GOVERNMENT OF THE DISTRICT OF COLUMBIA
DEPARTMENT OF TRANSPORTATION

MEMORANDUM

SUBJECT: ZC Case No. 15-11 – Square 700, Lots 43 and 866 – One M Street, SE

Figure 1 Site Design and Access (Source: Grove/Slade Associates)

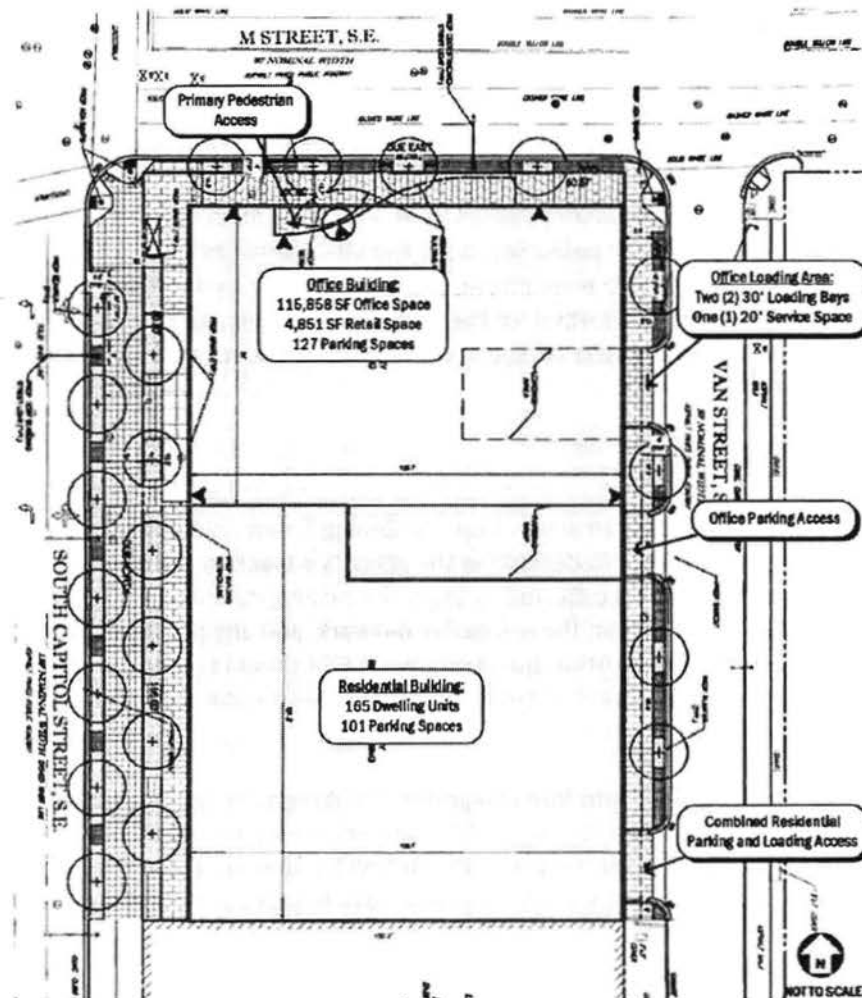
The Applicant proposes all vehicular access to the site on Van Street, which is a short local roadway between Half Street SE and South Capitol Street that connects M and N Streets. As shown in Figure 1, three curb cuts are proposed to provide vehicular access to the site. The northernmost curb cut will serve as the loading access for the office and retail building, the middle curb cut will serve as the parking access for the office and retail building, and the southernmost curb cut will serve as the parking and loading access for the residential building.

DDOT expects the Applicant to design and build the streetscape surrounding the property to current DDOT standards. As shown in the current plans, the proposed garage intake/vent at the corner of South Capitol Street and M Street prevents an additional tree from being planted and should be relocated to the building face, in line with the utility vaults. Additionally, a new curb ramp at southeast corner of M Street and Van Street is necessary to align with the existing crosswalk and bring the curb ramp up to current standards.

- Relocation of the garage intake/vent at the corner of South Capitol Street and M Street to the building face, in line with the utility vaults, in order to plant an additional tree;
